**Subject: Response to Second Request for Additional Information  
SCA Hartley & Hartley Landfill Site, Kawkawlin Township, Michigan  
NRC Source Material License No. SUC-1565**

### Responses to the USNRC's October 28, 2005 Request for Additional Information with Regard to the Decommissioning Plan for the SCA Hartley & Hartley Landfill Site Kawkawlin Township, Michigan

**Attachment 1B**  
**MicroShield Analysis**

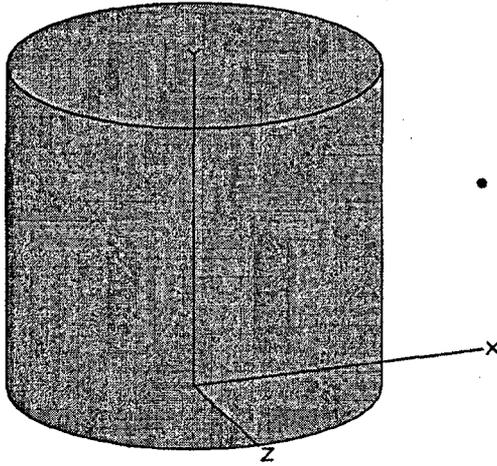
**Request #5:** **A dose analysis of the leachate collection system and the storage tank should be provided. In your DP, you indicated that a leachate extraction system will be installed in the Northwest Landfill and that the system would be used for an indeterminate period of time after the site had been released for unrestricted use. In your response to the RAI, you addressed the potential for exposure to**

radioactive contamination if the leachate system leaked during operation, the potential for exposure to contamination in the leachate piping during operation of the system, and the potential exposure of the workers to contaminated leachate in the storage tank. However, a dose analysis of exposure to the leachate collection system and the storage tank was not provided. Since you have requested that the site be released for unrestricted use, issues such as these regarding the operation of the system need to be addressed.

Response: S.C. Holdings concurs with the approach used by the Michigan Department of Natural Resources (MDNR) (and approved by the USNRC) to evaluate the potential radiological exposure from the leachate in the on-site storage tank<sup>(1)</sup>. Using the same approach, and incorporating radiological data for the leachate in the Northwest Landfill, as well as the projected potential levels of radioactivity in this leachate calculated using RESRAD, S.C. Holdings believes that future workers at the SCA Hartley & Hartley Landfill site will not be exposed to appreciable amounts of radioactive contamination stemming from operations involving leachate handling.

The USNRC's comment suggests that the unique properties of gamma radiation present an additional exposure pathway that does not require direct human contact with the leachate. The USNRC hypothesizes that the penetrating gamma radiation pathway (external pathway) could result in exposures to workers or visitors even if no leakage or direct contact with the leachate occurs. In response to the USNRC's concern, S.C. Holdings has formulated and evaluated an exposure scenario to address this potential exposure pathway. The exposure scenario involves an industrial worker who hypothetically stands 1 meter from the leachate storage tank for an entire work-year. In this scenario, the limited sections of the leachate transfer piping that extend above grade were not included because the vast majority of the leachate transfer piping is, and/or will be, buried below grade, and because it is more conservative to assume that a worker spends all work hours standing next to the larger source.

In addition, it was assumed that the 15,000-gallon leachate storage tank that was installed at the site this past summer to collect leachate from the East Landfill is used to collect leachate from the Northwest Landfill and the MDNR Landfill, as well. To be conservative, it was assumed that all of the leachate in the storage tank was extracted from only the Northwest and/or MDNR Landfills. (This is a simplifying conservative assumption because the thorium-bearing slag that was disposed in the Northwest and East Landfills was not known to have been disposed in the East Landfill. Ultimately, the contents of the storage tank will be a mixture of the leachate from each of the three landfills; however, the relative contribution from each landfill is difficult to predict and will likely vary over time.)

The modeled scenario was made even more conservative by assuming that the tank is always completely full (an impracticable, but simplifying and conservative, assumption), and that the concentration of residual radioactivity in the leachate is the maximum concentration projected over the 1,000-year outlook by RESRAD using the "system leakage" scenario. The "system leakage" scenario is also conservative, in that it assumes the presence of thorium radioactivity in slag at the specific activity limit.

The MicroShield computer modeling code (Version 5.01) (Grove Engineering, 1996) was used to assess the radiological exposure conditions resulting from a gamma radiation source. The MDNR used MicroShield in their analysis of the same exposure scenario. Under the above highly conservative exposure scenario, MicroShield projected a maximum potential gamma radiation exposure on the order of  $10^{-3}$  mrem/hr for a worker who hypothetically stands at a distance of 1 meter from the tank for an entire work-year. This converts to an annual gamma radiation dose of less than 2 mrem/yr (based on approximately 2,000 work hours per year). The results of this analysis are attached (see Attachment 1B) for the USNRC's review and consideration.
